State of New Mexico
Energy, Minerals and Natural Resources

SUNDRY NOTICES AND REPORTS ON WELLS
(DO NOT USE THIS FORM FOR PROPOSALS TO DRILL OR TO DEEPEN OR PLUG BACK TO A DIFFERENT RESERVOIR. USE "APPLICATION FOR PERMIT" (FORM C-101) FOR SUCH PROPOSALS.)
1. Type of Well: Oil Well [x] Gas Well [ ] Other [ ]
2. Name of Operator SILVERBACK OPERATING II, LLC
3. Address of Operator 19707 West IH 10, Suite 201 San Antonio, TX 78257
4. Well Location Unit Letter O : 660 feet from the South line and 1980 feet from the East line Section 08 Township 19S Range 25E NMPM County Eddy
11. Elevation (Show whether DR, RKB, RT, GR, etc.) 3545' GR

Silverback Operating II, LLC respectfully request permission to plug and abandon the subject well. Please see the attached operations procedure and wellbore schematics.

Roy AET #4  
30-015-26977  
8-19S-25E Unit O

# ROY AET #4 Proposed

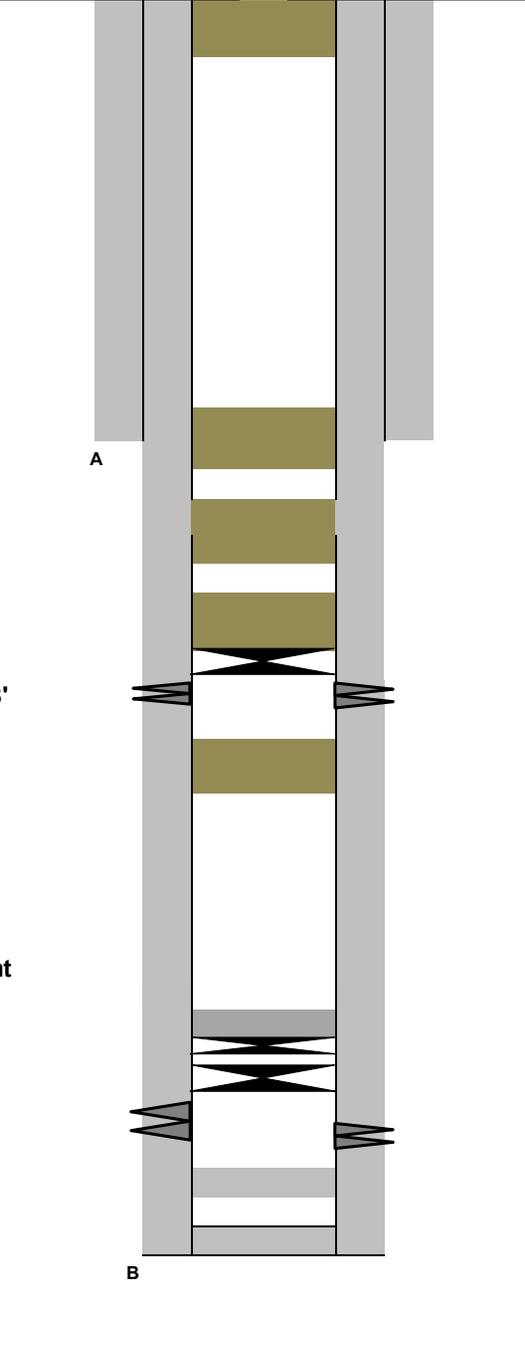
Run CBL

2a. Spot 25 sx cl H cmt or Dump Bail 6 sx cmt on existing plug at 7700' - WOC Tag and test well 500psi 30min if well does not test find leak before proceeding.

2b. Spot 25 sx cmt 5518' - 5378' - T of Wolfcamp

4. Spot 25 sx cmt 4868' - 4728' - T Abo

5. Spot 25 sx cmt - 2090' - 1950' - T Glorieta
